Re: NORTHEAST NUCLEAR ENERGY COMPANY, Millstone Nuclear
Power Station, Unit No. 2, Docket No. 50-336-OLA
(Spent Fuel Pool Design)

Millstone Nuclear Power Station, Unit No. 2
Proposed Revision to Technical Specifications
Spent Fuel Pool Modifications

Proposed Revision to Technical Specifications
Spent Fuel Pool Modifications

Marked Up Pages of Technical Specifications

FIGURE 3.9-1B MINIMUM REQUIRED FUEL ASSEMBLY EXPOSURE AS A FUNCTION OF INITIAL ENRICHMENT TO PERMIT STORAGE IN REGION C WITH POISON PINS INSTALLED

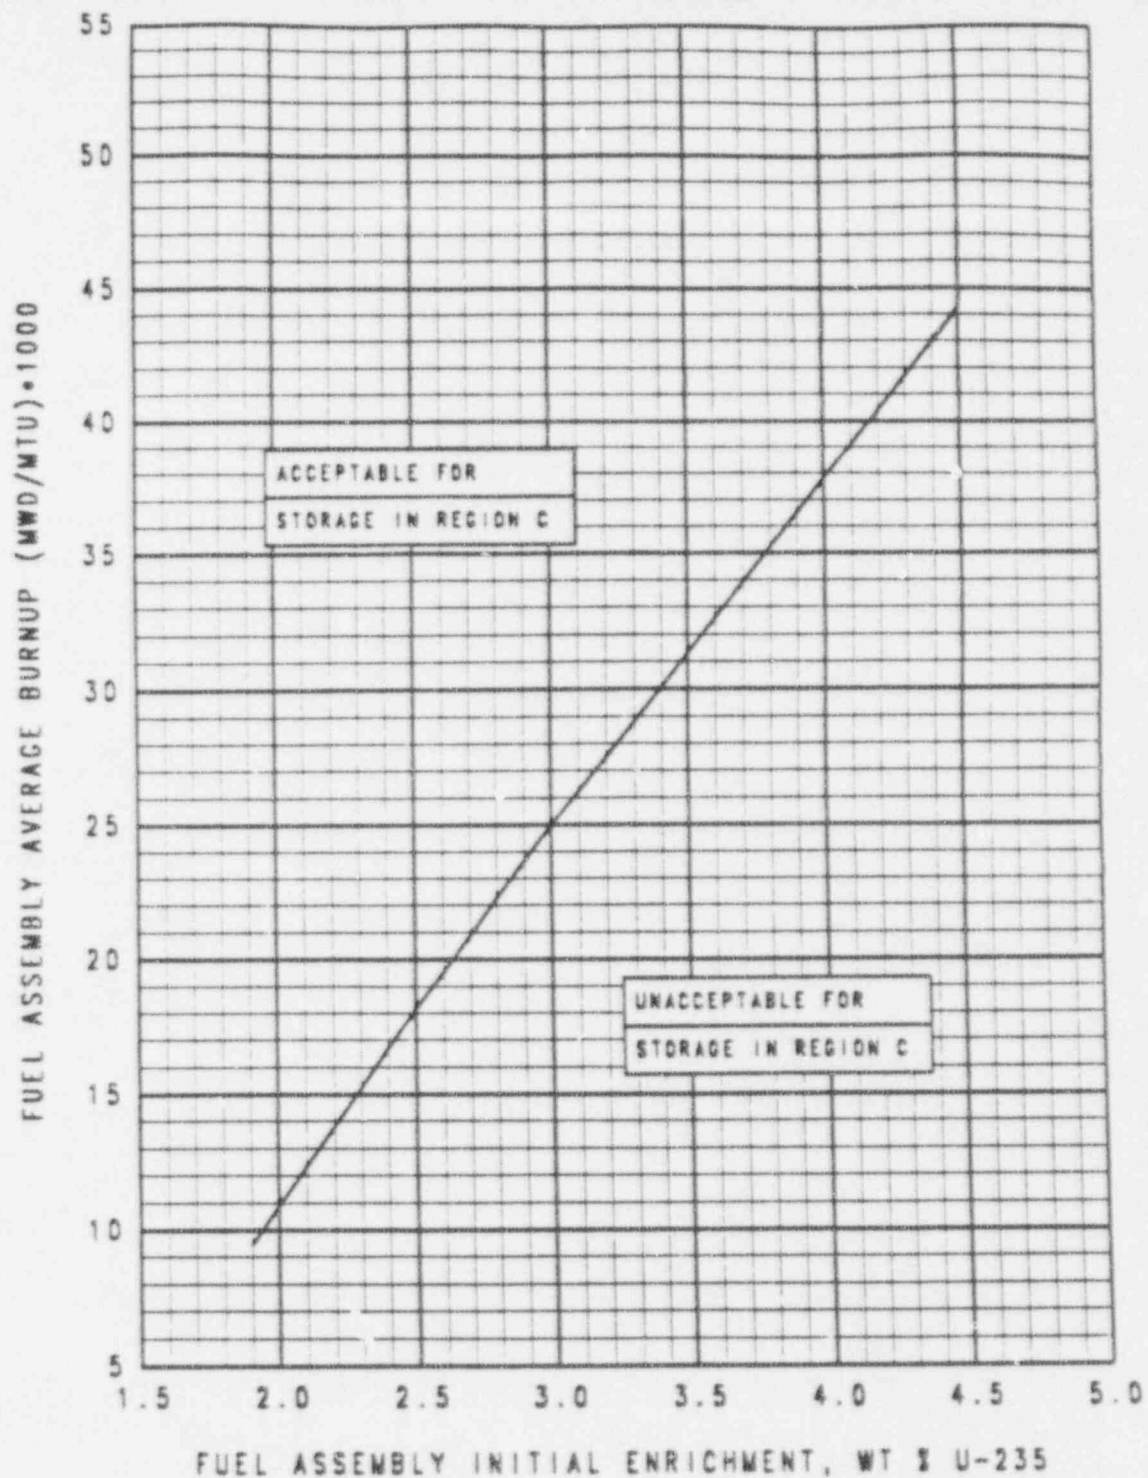
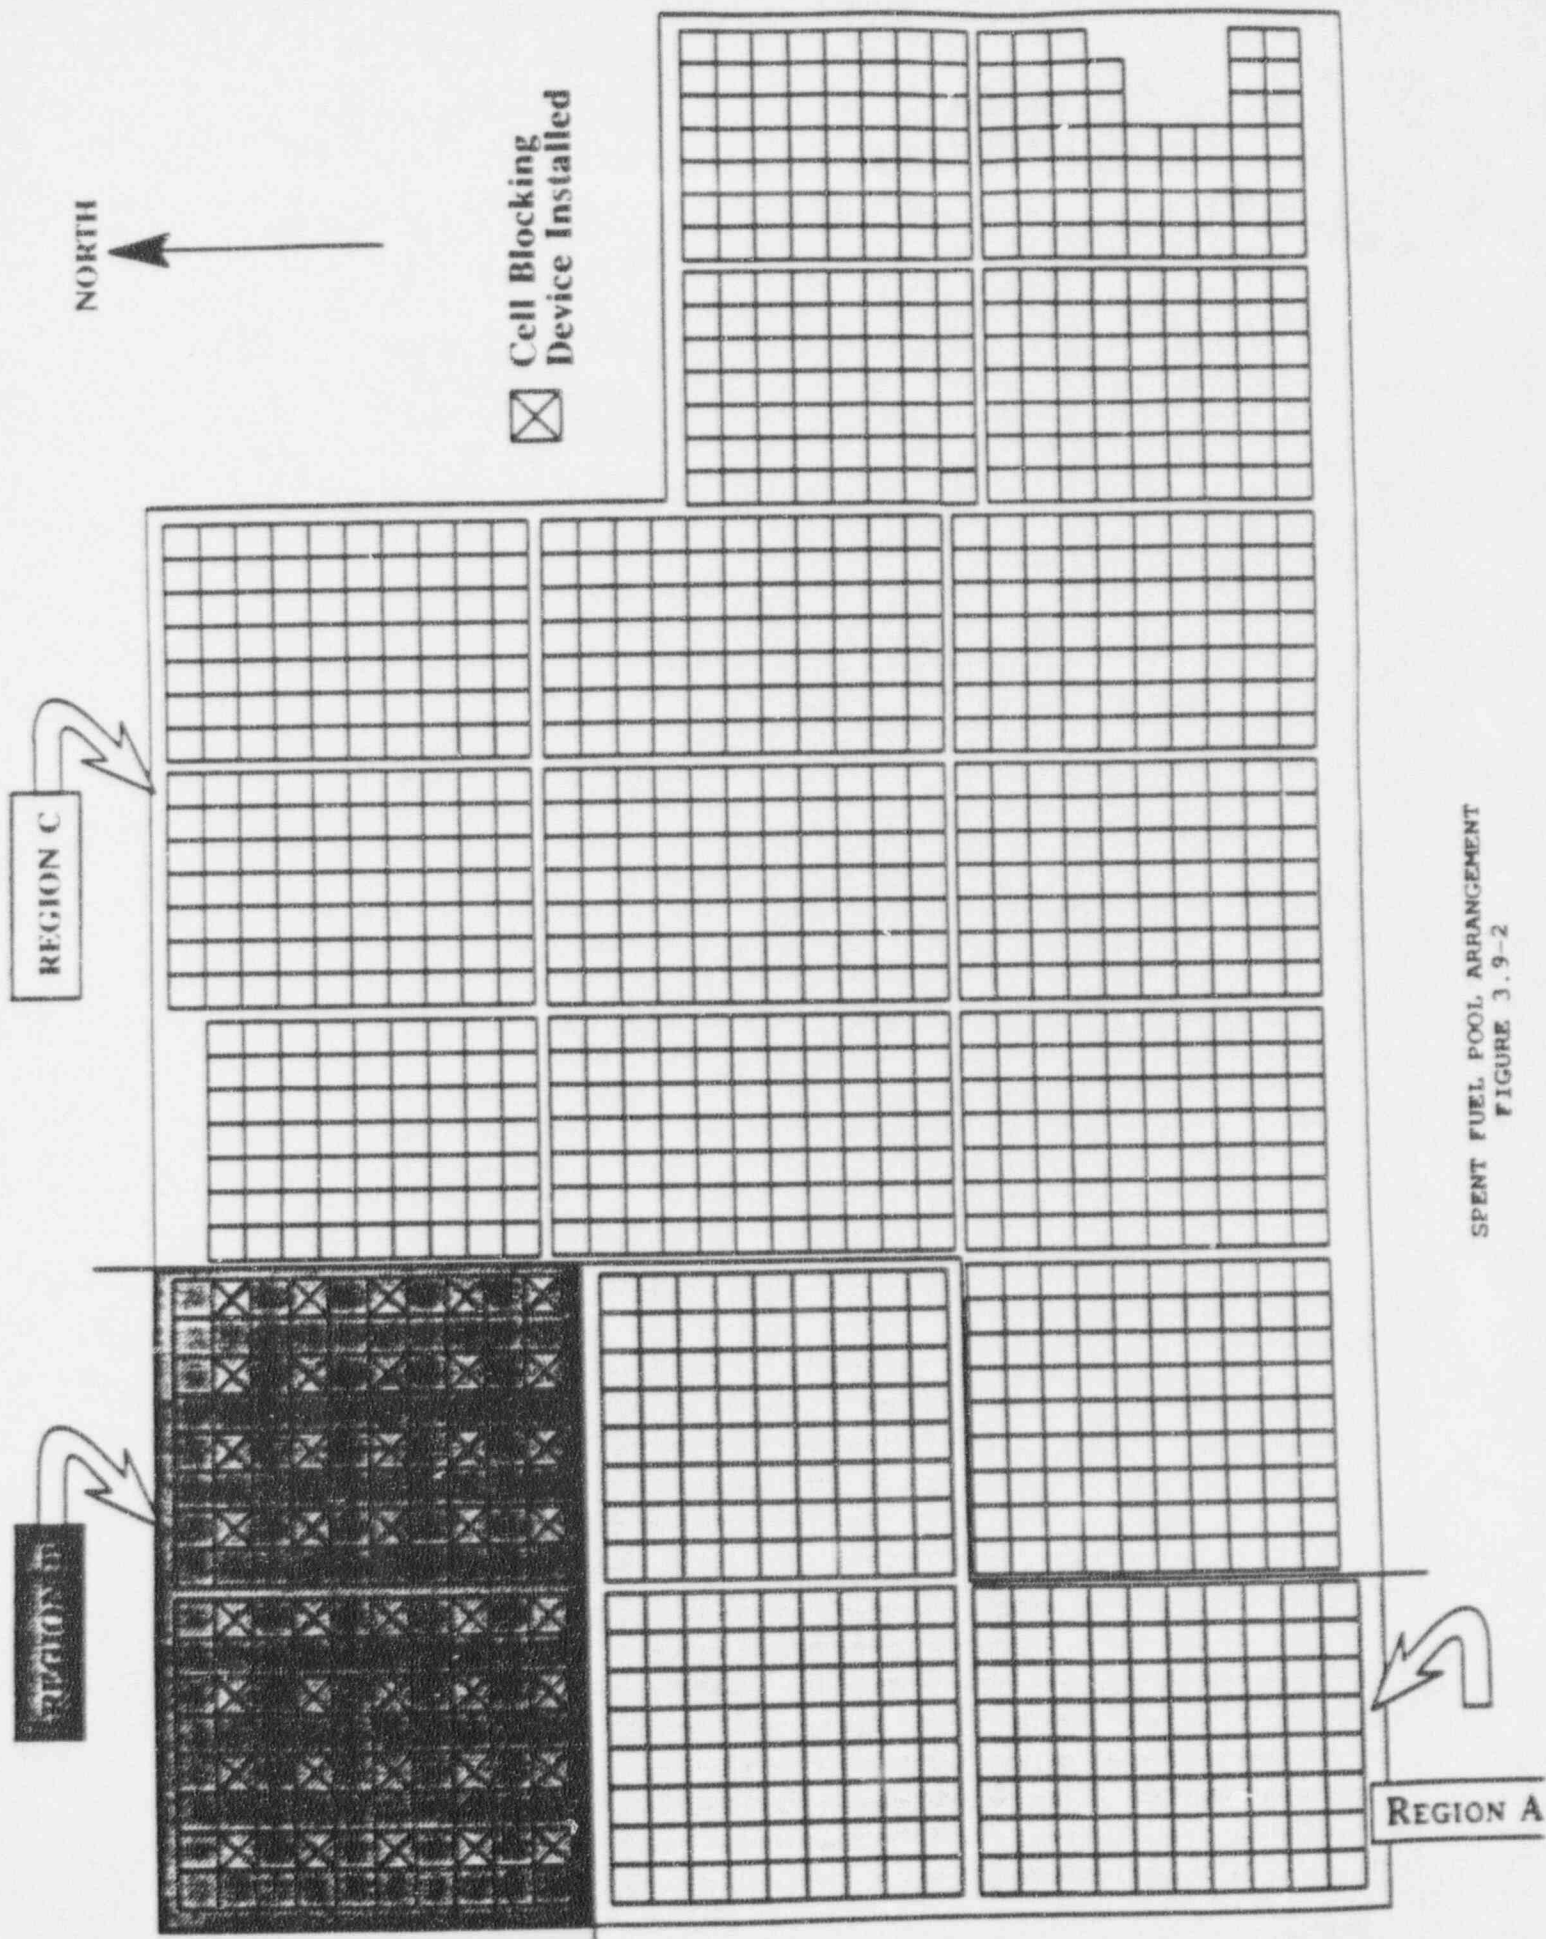
Figure 3.9-1, "Minimum Required Fuel Assembly Exposure as a Function of Initial Enrichment to Permit Storage in Region C," on page 3/4 9-23, is being changed to Figure 3.9-1a, "Minimum Required Fuel Assembly Exposure as a Function of Initial Enrichment to Permit Storage in Region C," to reflect the non-poisoned fuel assemblies to be stored in Region C; and Figure 3.9-1b, "Minimum Required Fuel Assembly Exposure as a Function of Initial Enrichment to Permit Storage in Region C with Poison Pins Installed," is being added as page 3/4 9-23a to reflect the poisoned fuel assemblies to be stored in Region C.

- (a) Fuel assembly enrichment and burnup are within the limits of Figure 3.9-1a by checking the assembly's design and burnup documentation; or
- (b) Fuel assembly enrichment and burnup are within the limits of Figure 3.9-1b by checking the assembly's design and burnup documentation, and borated stainless steel poison pins are installed in the assembly's center guide tube and in two diagonally opposite guide tubes.

Summary of Criticality Safety Calculations for
 Alternative Storage Arrangements in Millstone Unit 2

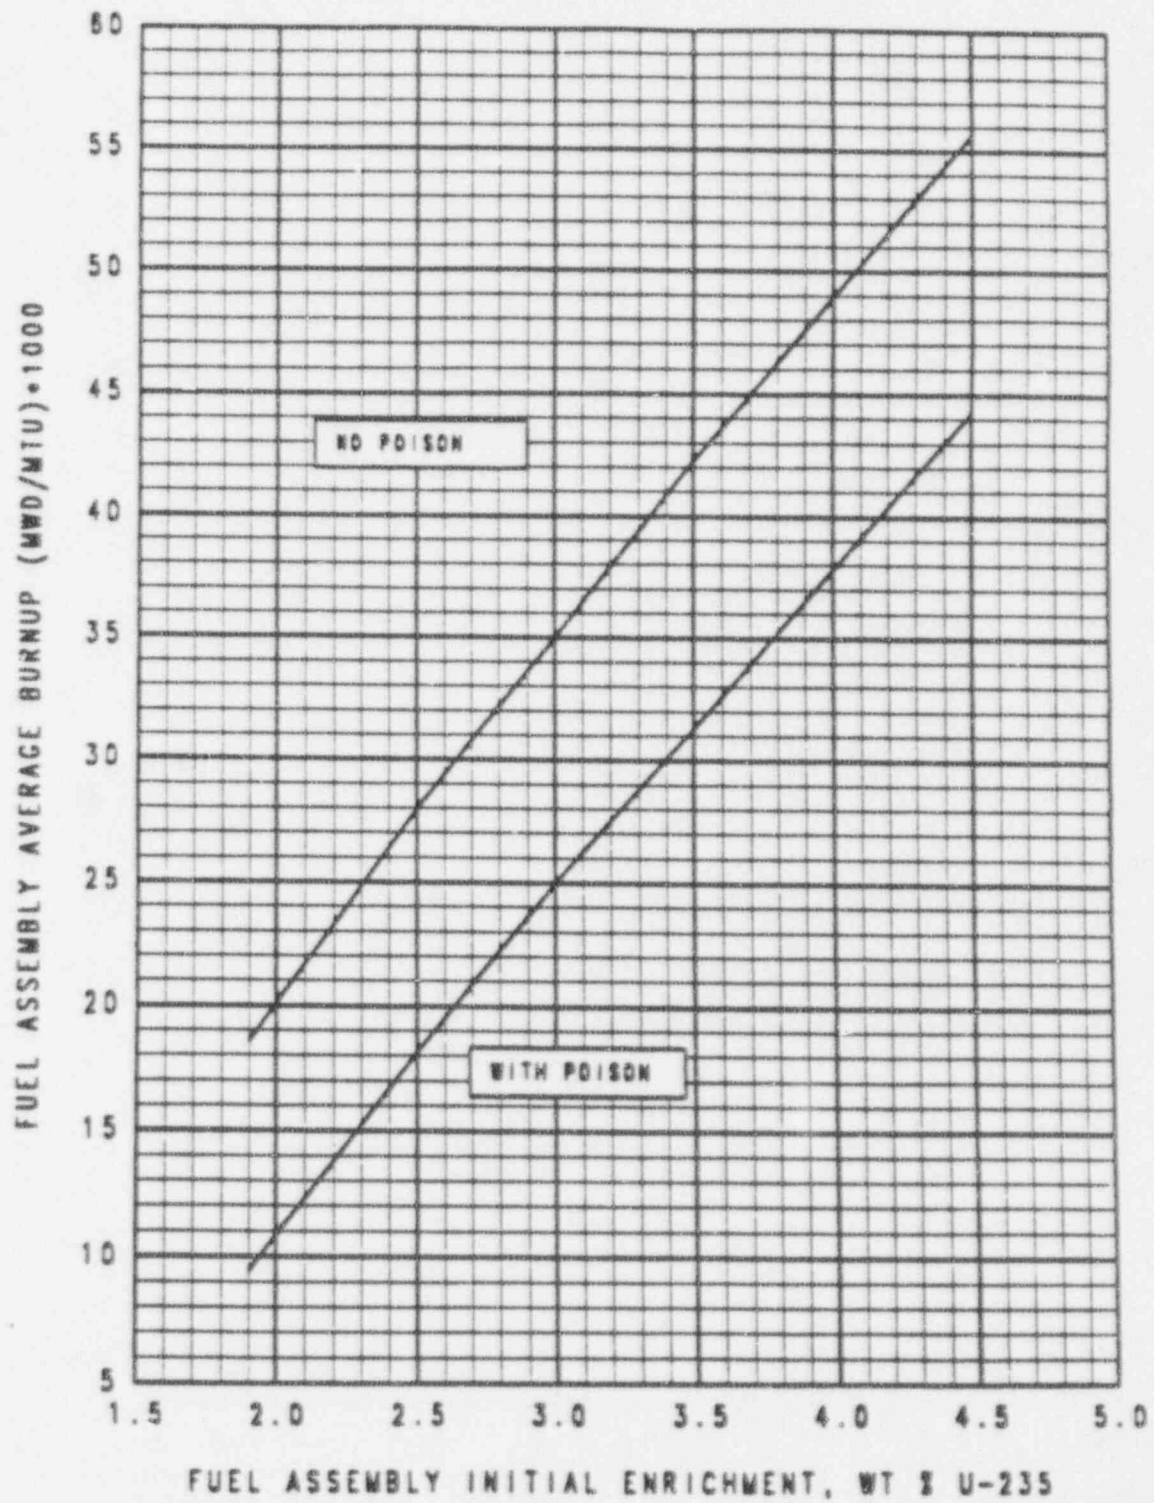
Region C is designed to use borated stainless steel (B-SS) rodlets or pins inserted into the control rod thimbles (3 rodlets per assembly). Analysis for this arrangement resulted in a maximum K_{eff} of 0.940 including calculational and manufacturing uncertainties. The analysis also includes the effect of axially distributed burnup in the assembly. Table 1 summarizes the calculations for Region C. Calculations were also made to define the burnup limit curve as a function of the initial enrichment. Figure 1 is the limiting burnup curve, yielding at each enrichment the same maximum K_{eff} (0.940). This burnup-limit

Region C is designed to safely accommodate spent fuel without any poison rodlets and utilizing all cells (4-of-4 arrangement). This requires a higher burnup and the burnup limit curve is shown in Figure 1. The maximum calculated K_{eff} in Region C with no poison pins is 0.9459, as indicated in Table 1, including uncertainties and the estimated reactivity consequence of axial burnup distributions.
